M 10 G / 10GA

NATURE AND REASON FOR CHANGE Change TORROID (L11) ground Ref coil
for MIDX RF out put from 4 TURN to 2 TURN
This will take out about 75MHz of Base line OSC.

LA 006-004

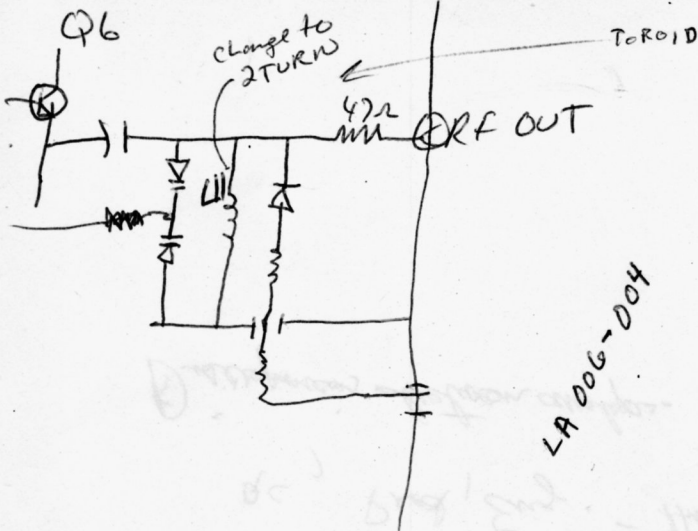
Help considerable amount every time Perm. Change.

- L11-1210-30-0005 4TURN*
- 1210-30-0003 2TURN*
